MFN 06-189
Supplement 1

Subject: **Response to Portion of RAI Letter Number 20 Related to ESBWR Design Certification Application – Seismic Design – RAI Numbers 3.7-8S1, 3.7-11S1, 3.7-25S1, 3.7-26S1, 3.7-52S1, and 3.7-55S1 – Supplement 1**

**RAI Numbers 3.7-8S1, 3.7-11S1, 3.7-25S1, 3.7-26S1, 3.7-52S1,
and 3.7-55S1**

Figure 3.7-11 (1) - Comparison of North Anna ground motion spectra at the CB and RB/FB (and other) horizons with a RG 1.60 spectrum anchored to 0.3g PGA.

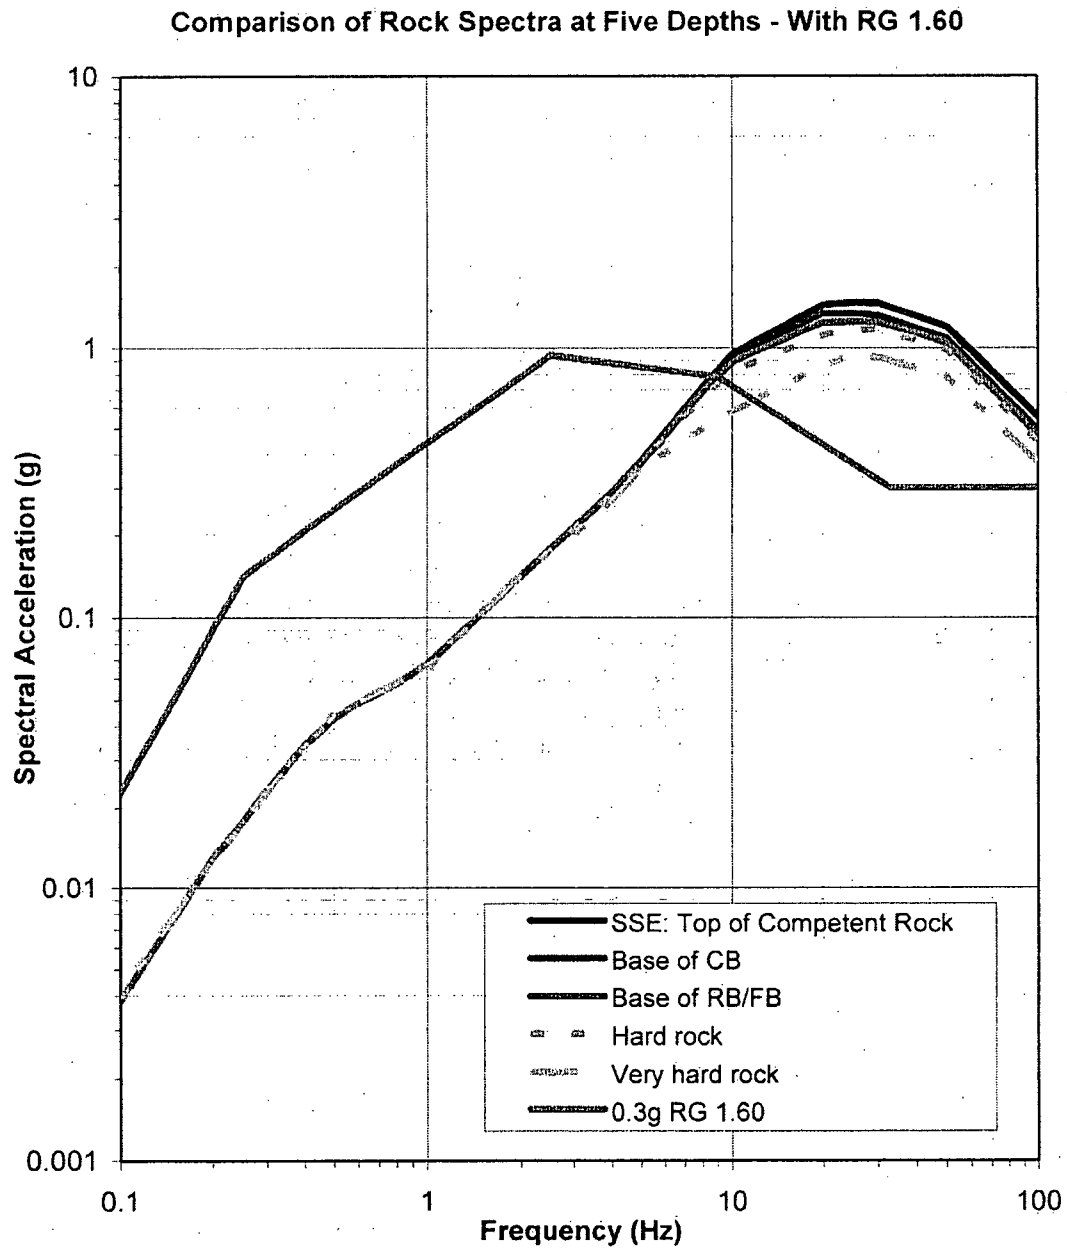
In the fourth sentence of the first paragraph of DCD Section 3.7.1.1.3 (Page 3.7-4), the applicant stated that, since the low frequency part of North Anna SSE ground response spectra are enveloped by the 0.3g RG 1.60 generic site response spectra with large margins, only the high frequency part needs to be explicitly taken into account. The staff requests the applicant to provide justifications for the conclusion drawn in the DCD and a comparison plot of these two sets of ground response spectra in Tier 2 DCD Section 3.7.1, "Seismic Design Parameters."

Provide additional clarification for the second sentence description provided in the last response submitted.

The spectra of Figure 3.7-7 (1) are the envelopes of high and low frequency target spectra used to define outcrop ground motions at horizons within the site rock profile. Figure 3.7-11 (1) reproduces the CB and RB/FB spectra of Figure 3.7-7 (1) and adds RG 1.60 anchored to a PGA of 0.3g. Comparison of this figure with DCD Figure 2.5-1 implies that the high frequency target spectra (shown in DCD Figure 2.5-1) control motions for frequencies above about 2 Hz, and that the low frequency target spectra (enveloped by the low frequency part of the spectra in Figure 3.7-7 (1) above) control motions for lower frequencies. It is apparent that the RG 1.60 spectrum envelopes by a factor of over 5 the low frequency part of the site-specific ground motion spectra for all evaluated North Anna Early Site Permit horizons (including the CB and RB/FB base horizons).

“The spectra of Figure 3.7-7 (1) are the envelopes of high and low frequency target spectra used to define outcrop ground motions at horizons within the site rock profile. Figure 3.7-11 (1) reproduces the CB and RB/FB spectra of Figure 3.7-7 (1) and adds RG 1.60 anchored to a PGA of 0.3g. It is apparent that the RG 1.60 spectrum envelopes by a factor of over 5 the low frequency part of the site-specific ground motion spectra for all evaluated North Anna Early Site Permit horizons (including the CB and RB/FB base horizons).”

Figure 3.7-25 (1) - Crane Location for Seismic Analysis

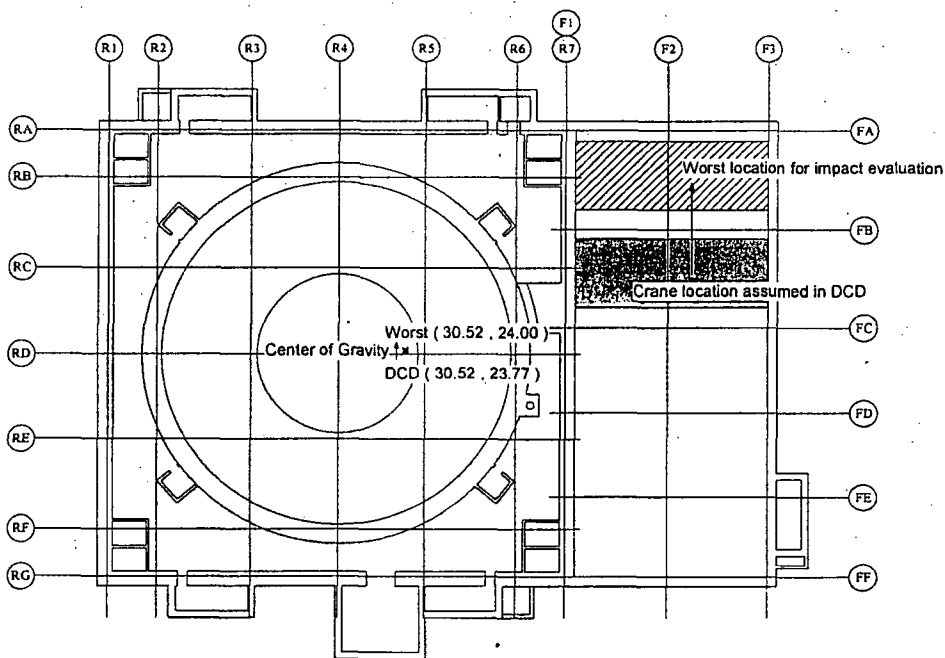
For the development of the RB/FB seismic model, the staff requests the applicant to specify in the DCD where the heavy crane (with trolley) is to be parked during plant operation. This information is needed to properly locate the mass and assess the effects of mass eccentricity in the seismic analysis. This information also needs to be identified as an interface item for the COL applicant.

Describe the effect of location of the main RB crane parking location on the design loads for individual structural members.

For the development of the RB/FB seismic model, the heavy crane (with trolley) is assumed to be parked between col-rows R3 and R4 in the RB and between col-rows FB and FC in the FB.

In order to assess the effects of crane location in the seismic analysis, the change of mass eccentricity was calculated varying the crane locations. A worst location is considered in the sensitivity analysis. Figure 3.7-25(1) shows the changes of the centers of gravity at the RB and FB crane floors. The centers of gravity moved only 25 cm maximum. Table 3.7-25 (1) shows comparison of eigenvalue analysis results for RBFB model in Fixed-base case. It is found that the difference of frequencies due to the crane location is negligibly small.

For the NASTRAN stress analysis, the crane locations are assumed as shown in Figures 3.7-25 (1) and 3.7-25 (2). The column R3/RB (i.e. column at the intersection of grid line R3 and grid line RB) and column R4/RB support the heaviest load from the RB crane. The columns F3/FB and F3/FC support the heaviest load from the FB crane. By using the stresses obtained from the stress analyses for these heaviest loaded columns, all the columns are designed and sized for the worst loading possible. Therefore, the crane can be parked anywhere from a structural design viewpoint.

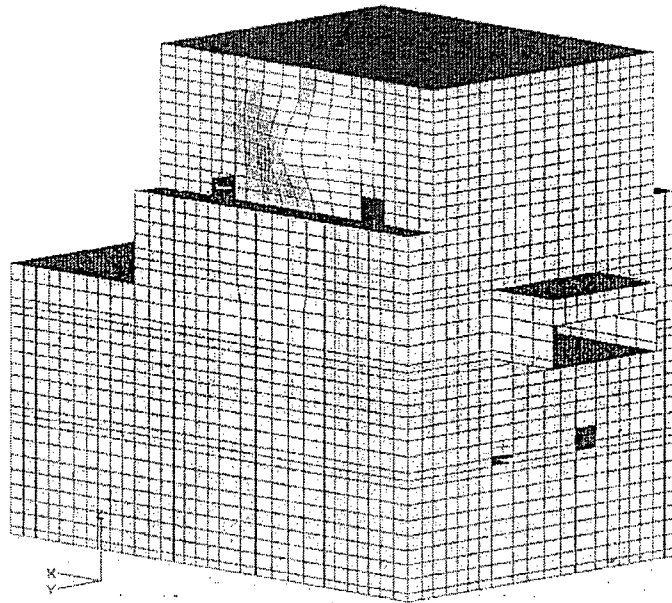
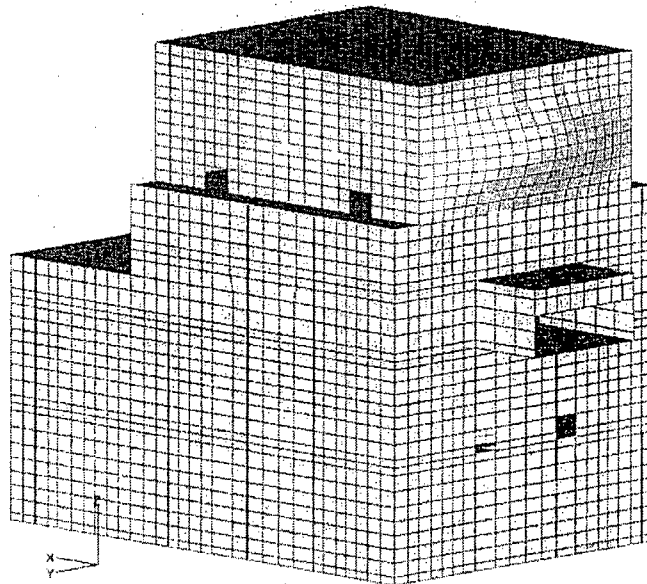
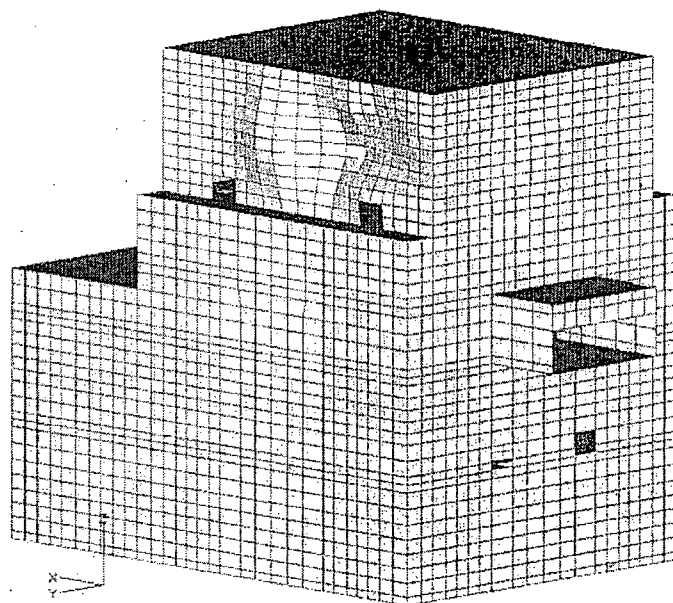
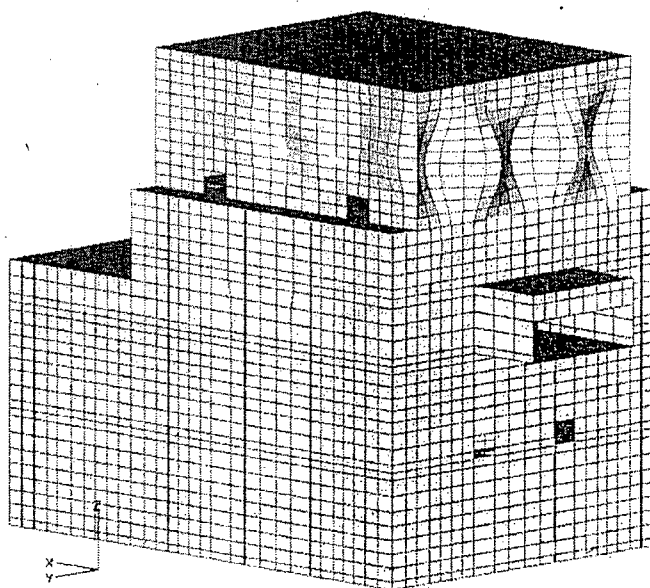
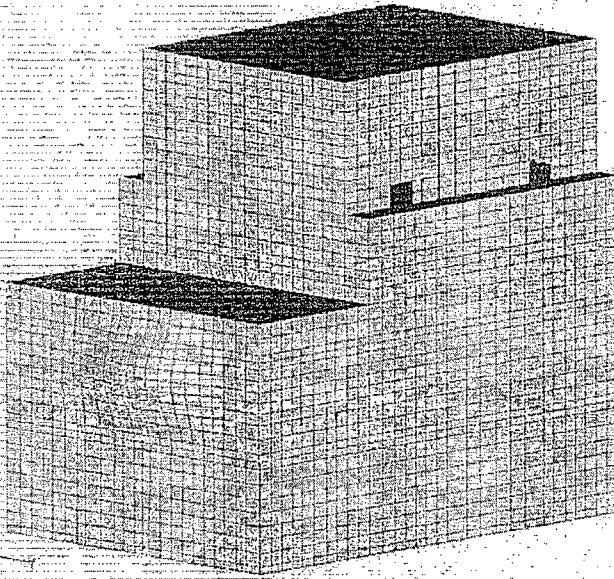
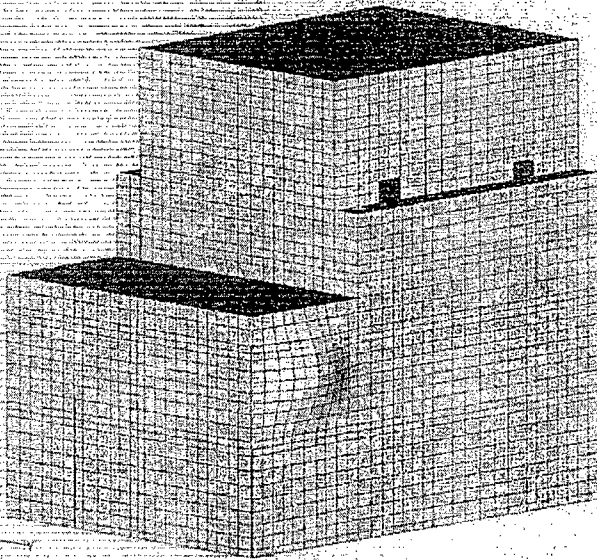
Review calculations for out-of-plane vibrations and document the results.

The out-of-plane vibration frequencies of walls were reviewed. As shown in Table 3.7-26 (1), the calculated out-of-plane fundamental frequencies for the typical walls in the RBFB and the CB are higher than the highest frequency of interest of 50 Hz. However, since the RB walls above the refueling floor at EL 34.0m and the FB walls at EL 4.65m have large heights to the upper floor, their frequencies are expected to be lower than 50 Hz. They are evaluated by using FEM model in the same manner as the slab frequencies. The eigenvalue analysis results are shown in Tables 3.7-26 (2) and 3.7-26 (3). Their mode shapes are shown in Figures 3.7-26 (1) through 3.7-26 (8).
